A d d e n d u m

Iowa Department of Transportation
Office of Contracts

B.O.	Proposal ID	Proposal Work Type	County	Project Number	Addendum
101	34-2189-132	Bridge Approach Repair	Floyd	NHSN-218-9(132)--2R-34	21aug101.a01

ENGLISH 7/17/2012 **DESIGN TEAM Humpal** PROJECT NUMBER **NASH-218-9(132)-2R-34** COUNTY **FLOYD** SHEET NUMBER **U.1**

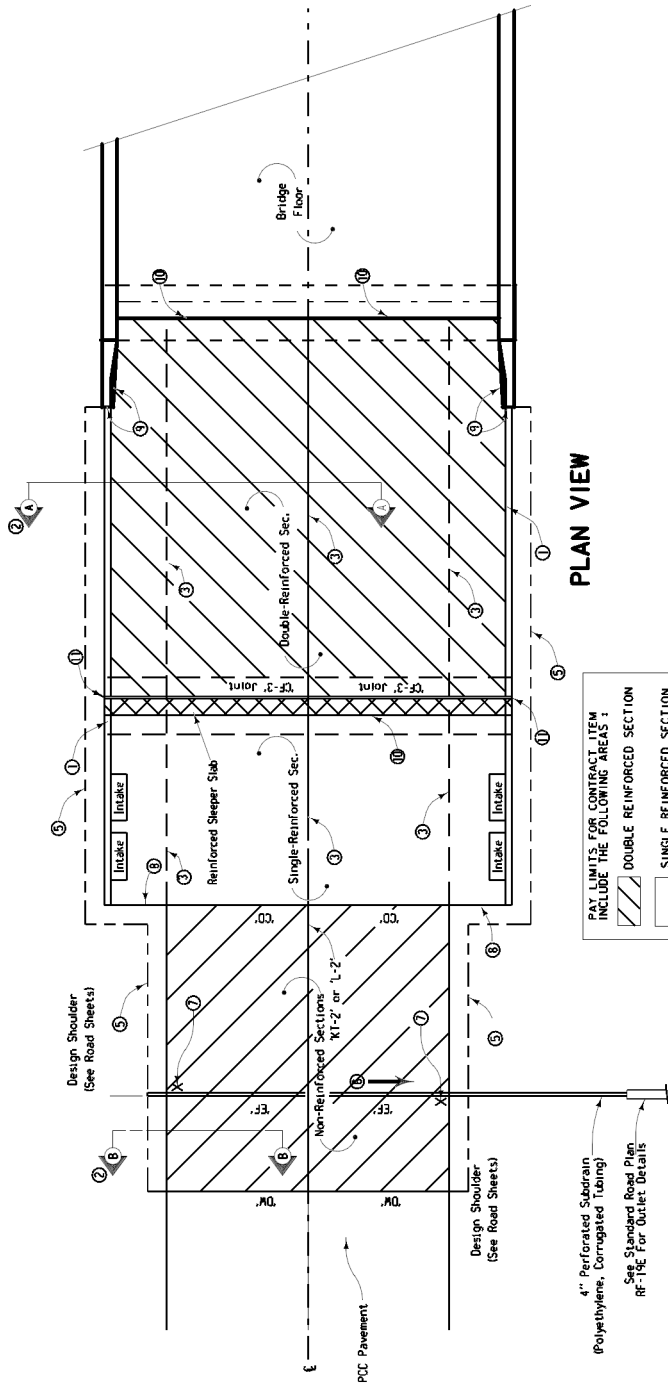
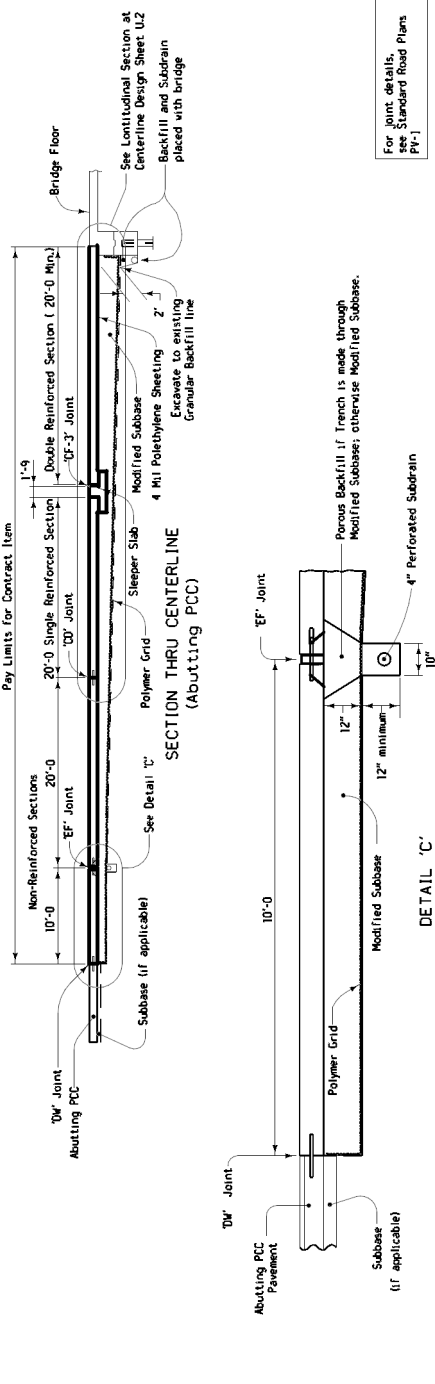
Delete the following Plan Sheets U.1, and U.2

ADD the attached Plan Sheets U.1, U.2, and U.3
